Annex J Heworth Ward

J1

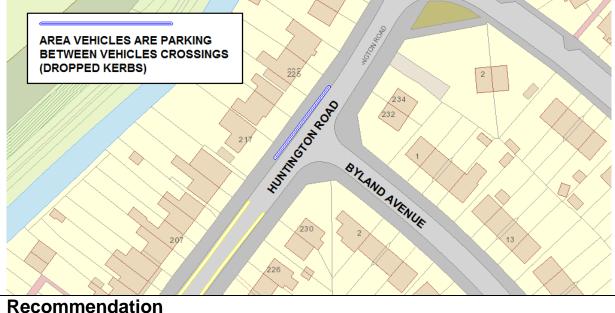
Location: Huntington Road/Byland Avenue roundabout.

Resident has raised an issue of vehicles parking on the pavement and restriction visibility when the resident is attempting to access/exit their private driveway, which is very close to the mini-roundabout on Huntington Road.

217-225 Huntington Road all have vehicle crossings(dropped kerbs) and private driveways. The footpath adjacent to the mini roundabout is 4-4.5metres in width. The footpath is segregated between paved footpath and tarmaced area where vehicles park.

No action. Restrictions on the carriageway would not be enforceable against vehicles parked on the metalled area.

Location: Harcourt Street/Glen Road

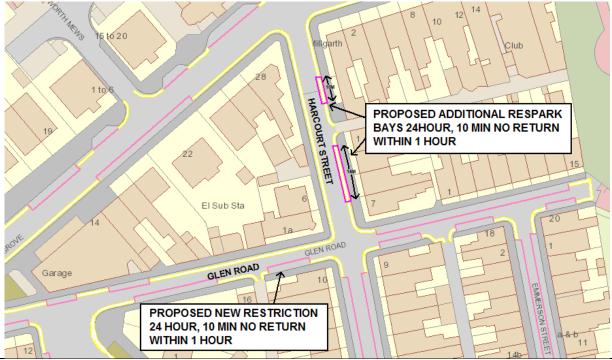
Resident of Harcourt Street has raised the issue of difficulties when trying to find a parking space within the existing Respark parking bays. Resident lives in the section between Hawthorn Grove roundabout and Glen Road. Resident also states the existing bays that have a restriction of 1 hour parking, no return within an hour are being used by taxi's as a waiting area leading to further difficulties when residents try to park.

Harcourt Street and Glen road are within the R30 Respark Zone. Three parking bays that are located on Glen Road between Harcourt Street and Hawthorn Grove currently allow 1 hour parking with no return within 1 hour.

To revoke a 10m and 15m section of double yellow lines on Harcourt Street and install two Respark parking bays. To change the parking restriction on one bay on Glen Road from 1 hour parking to 10 minute parking, no return within 1 hour.

Cllr. R. Webb- I am happy with the suggestion for J2 on Harcourt St as proposed.

Location: Thornfield Avenue

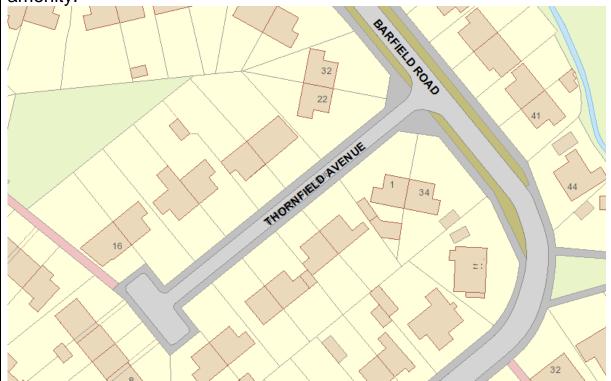
Resident has raised the issue of vehicles parking on the carriageway and footpath leading to restricted access to the full length of the street.

Thornfield Avenue is a residential cul-de-sac with a carriageway width of 3metres. Some properties have vehicles crossings and off street parking amenity.

No Action. Any parking on the footpaths causing an obstruction should be reported to the police.
